TRANSCEIVER MODULE DATA IN SUPPORT OF COMMENTS #396 AND 397 AGAINST D1.2

Roberto Rodes, Coherent

- **This presentation is in support of the comments #396 and 397 to specify TECQ/TDECQmax= 3.4dB, while maintaining current SER target.**
- **Module with high TDECQ was used to get data on TDECQ measurement capabilities and Rx performance postFEC**

HIGH TDECQ MODULE AT 200G/LANE

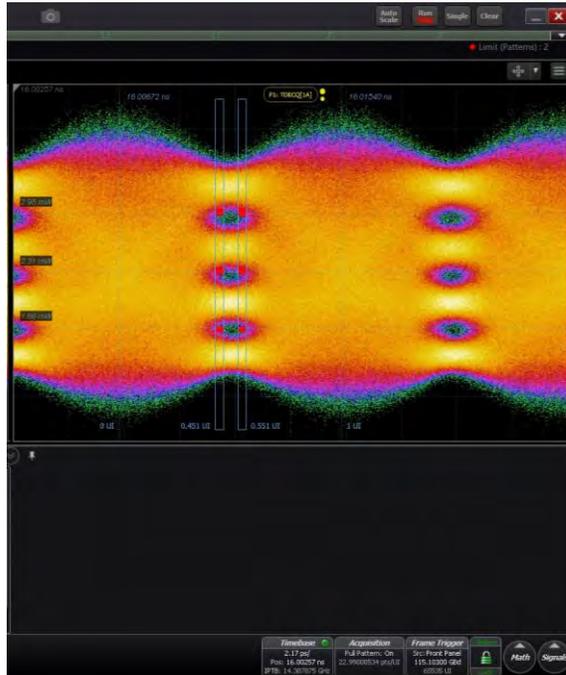
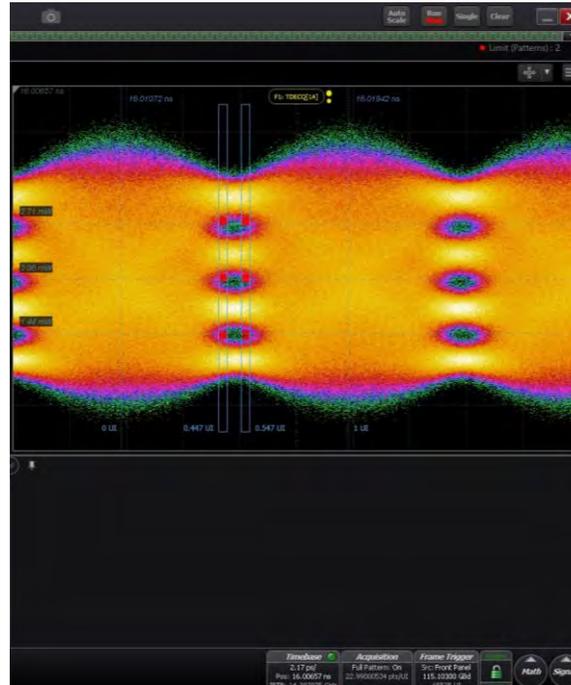
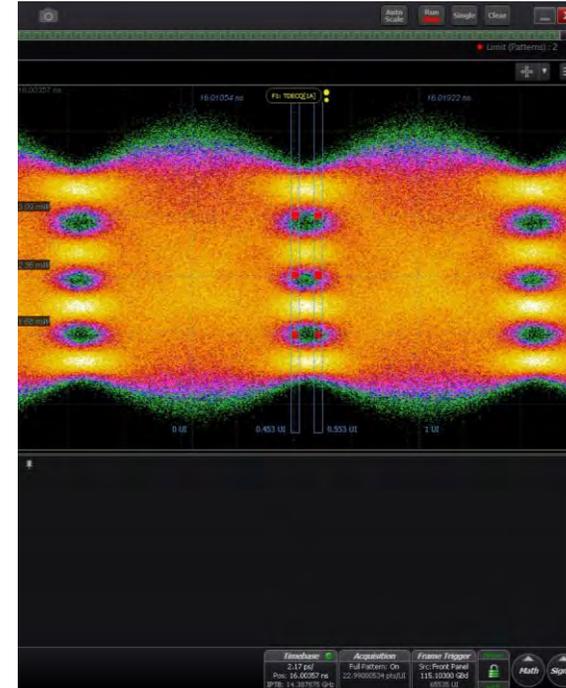
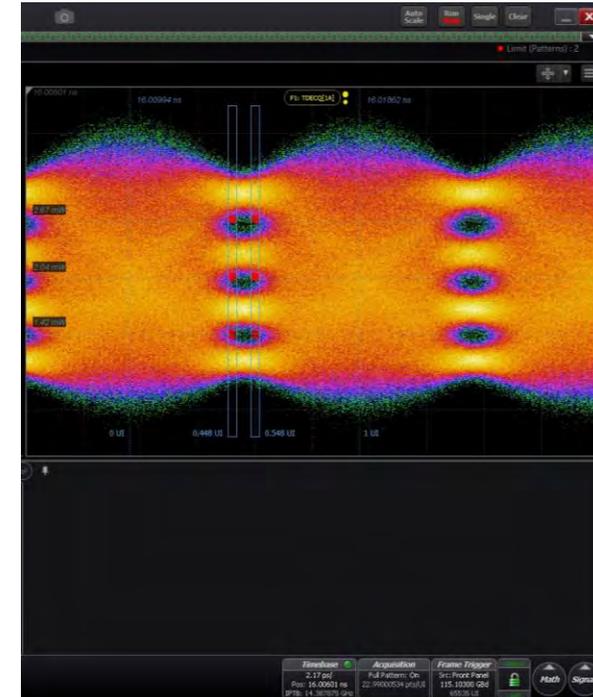
- 800G-FR4 module with inner FEC
- 115GBd
- SSPRQ
- 15-tap TDECQ
- All lanes > 3.5 dB TECQ @ 9.6e-3 SER

WATERFALL POST INNER FEC BER

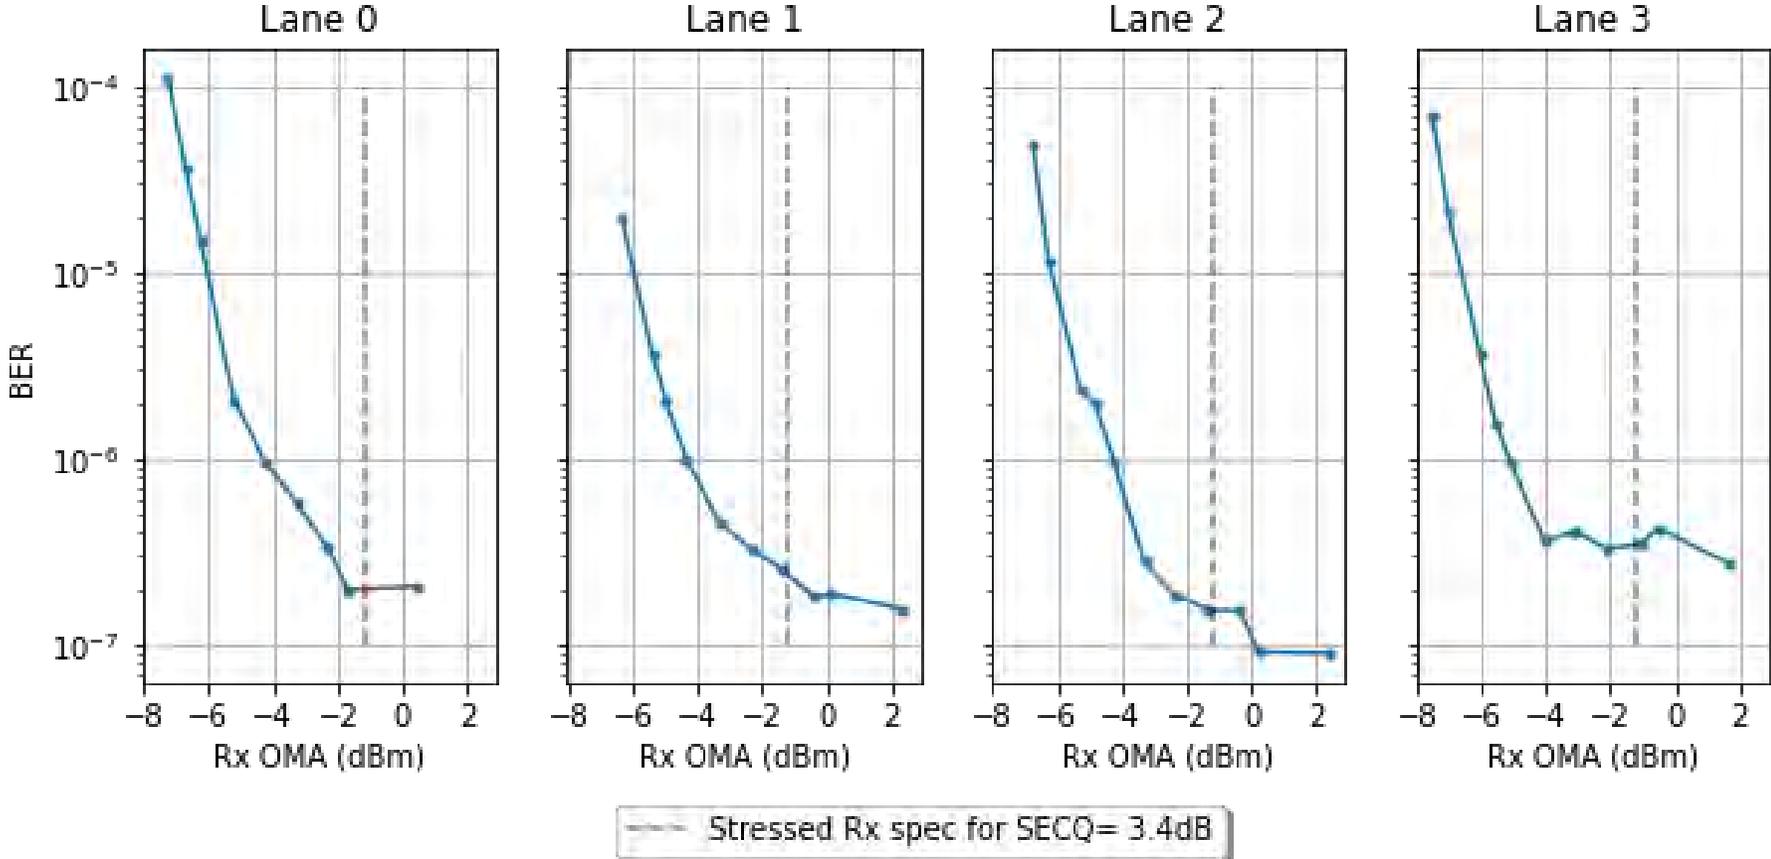
All receivers show < 1e-6 BER the SRS spec limit of -1.2* dBm

*assumes proposed SECQ/TECQmax= 3.4dB

POST FEC PERFORMANCE

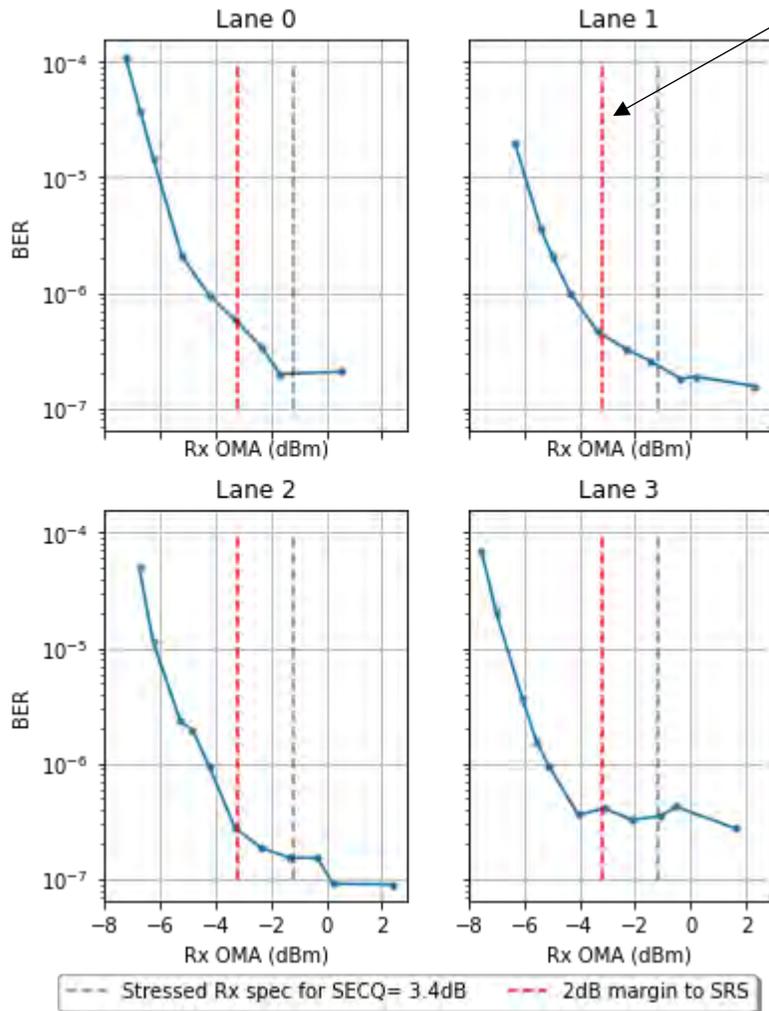
Codeword error ratios measured 2dB margin to SRS spec

All lanes show good codeword error ratio with margin ⁷

800G-FR4 module lane#3

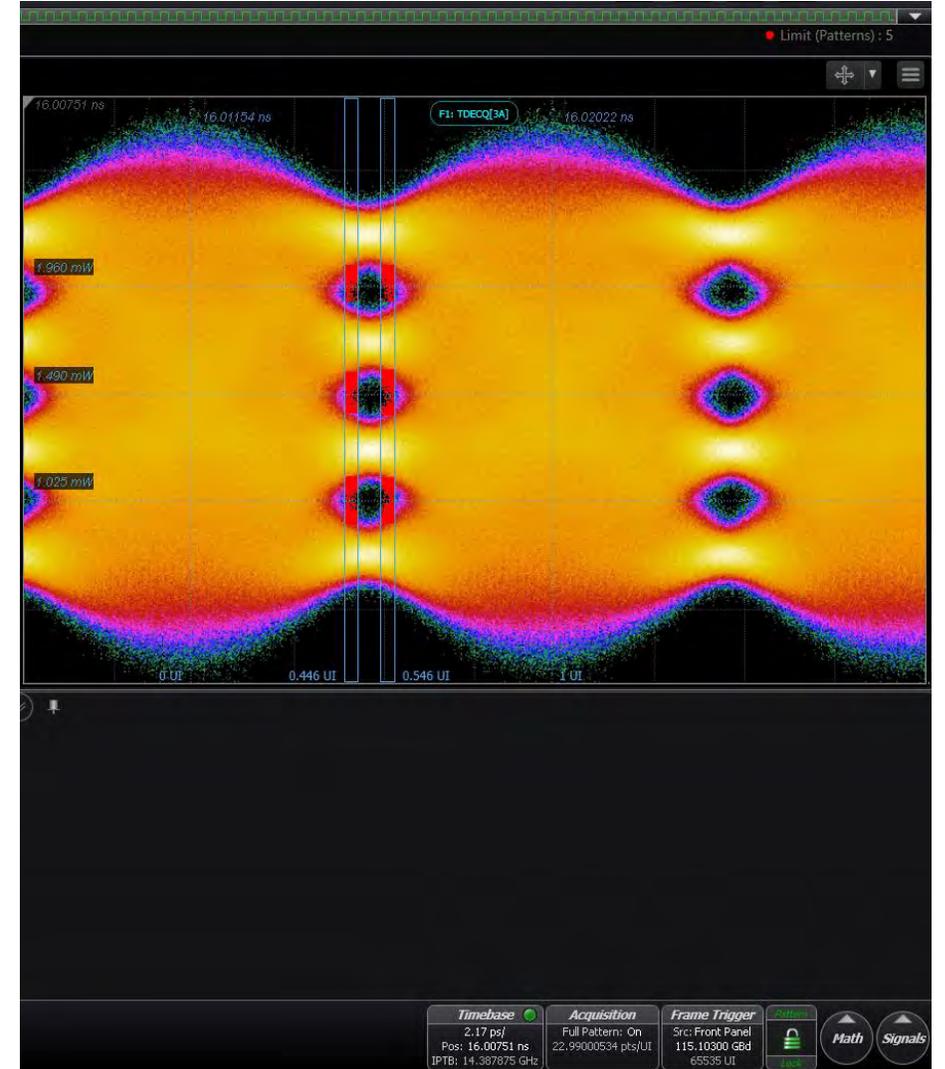
Different module than previous section to meet TECQ with and w/o inner FEC

Using same $4.8e-4$ will make innerFEC spec significantly more challenging for the same Tx

SER of $6e-3$ shows a similar TECQ value when operating at innerFEC baudrate compared to no innerFEC at $4.8e-4$

RX PERFORMANCE WITH AND WITHOUT INNER FEC. RX SENSITIVITY

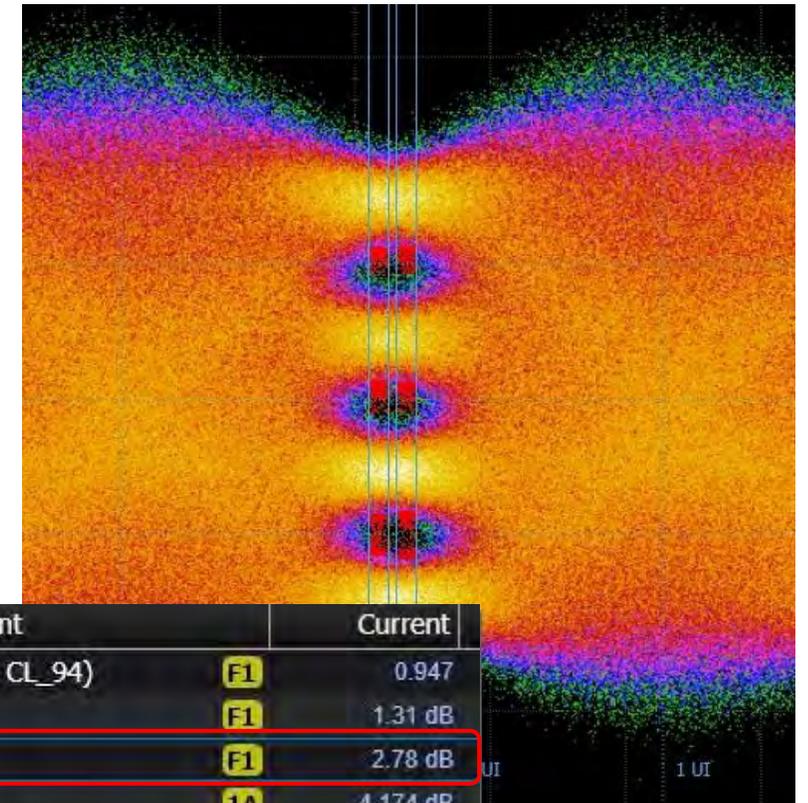
Same 800G-FR4 module is tested with and without innerFEC in loopback configuration. Reducing Rx OMA until lane#3 hits same BER (1e-5) on both configurations. The same receiver, shows ~2dB better Rx sensitivity with the Transmitter when using innerFEC. TECQ , which correlates with Rx sensitivity, should reflect that improvement.
